PRODUCT/PROCESS CHANGE NOTICE (PCN)

PCN #: **TB1503-01 (R1)** DATE: **October 23, 2015**
 Product Affected: **TSSOP-20, TSSOP-24, TSSOP-28,**
 TSSOP-48, TSSOP-56, TVSOP-48
 SOIC-28, SSOP-20, SSOP-28,
 (Refer to Attachment II for affected part# shipped in Reel)
 Date Effective: **February 1, 2016 Earliest Date - Refer to**
 specific date by package type

Detail of Change: This notification is to advise our customers that IDT has planned to standardize the carrier tape on the selective package types to only one type as detailed below.

Figure 1: Additional Label pasted on ESD/Moisture barrier bag and Pizza box

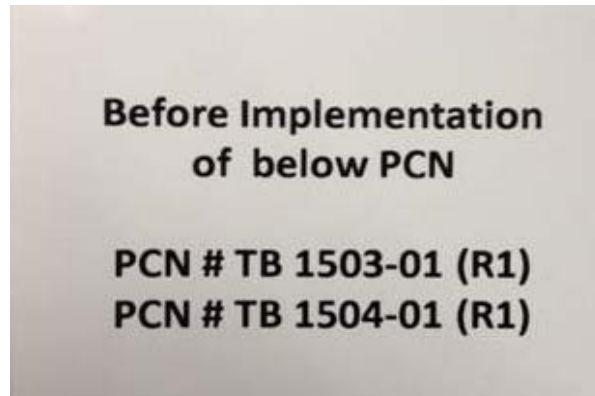
Customers may expect to receive shipments of products in new packing no sooner than 90 days from the date of this PCN notification. Shipments to customers may contain products shipped with either the existing packing or new packing during the transition period. Shipments made in the existing packing after the PCN becomes effective will have an additional label pasted on the ESD/moisture barrier bag and pizza box.

Illustration of Carrier Tape Pocket Design Change

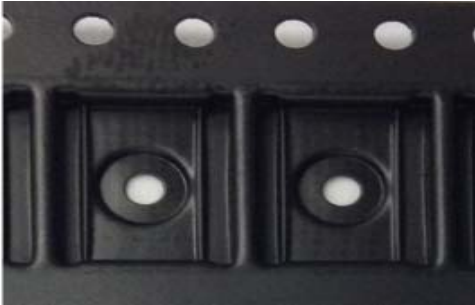
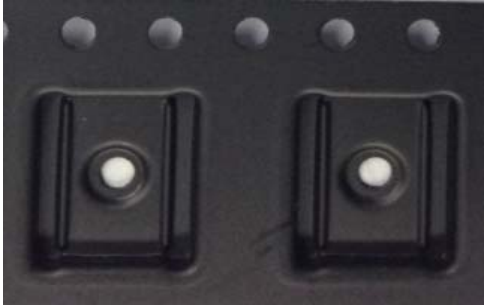
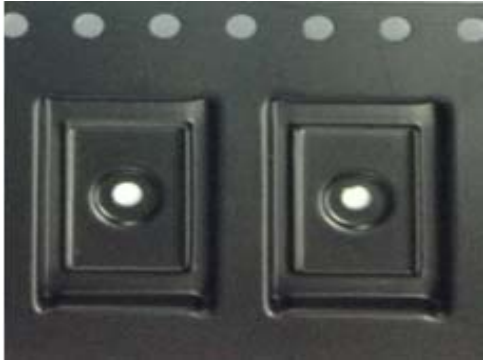
Package	From	To
TSSOP-20	Carrier Tape Part# P8-464-000 	Carrier Tape Part# P8-291-P20 
TSSOP-24	Carrier Tape Part# P8-329-P24 	Carrier Tape Part# P8-169-P24 
TSSOP-48	Carrier Tape Part# P8-260-P48 	Carrier Tape Part# P8-324-P48

Illustration of Carrier Tape Pocket Design Change

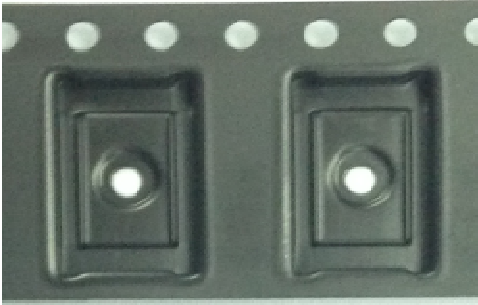
Package	From	To
SOIC-28	Carrier Tape Part# P8-187-S28 	Carrier Tape Part# P8-370-P28 
TSSOP-28 and TVSOP- 48	Carrier Tape Part# P8-145-PF8 	Carrier Tape Part# P8-330-P48 
TSSOP-56	Carrier Tape Part# P8-261-P56 	Carrier Tape Part# P8-314-P56

Illustration of Carrier Tape Pocket Design Change

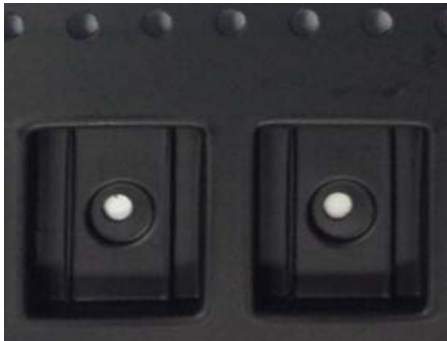
Package	From	To
SSOP-20	Carrier Tape Part# P8-259-P20 	Carrier Tape Part# P8-320-P20 
SSOP-28	Carrier Tape Part# P8-384-P28 	Carrier Tape Part# P8-321-P28
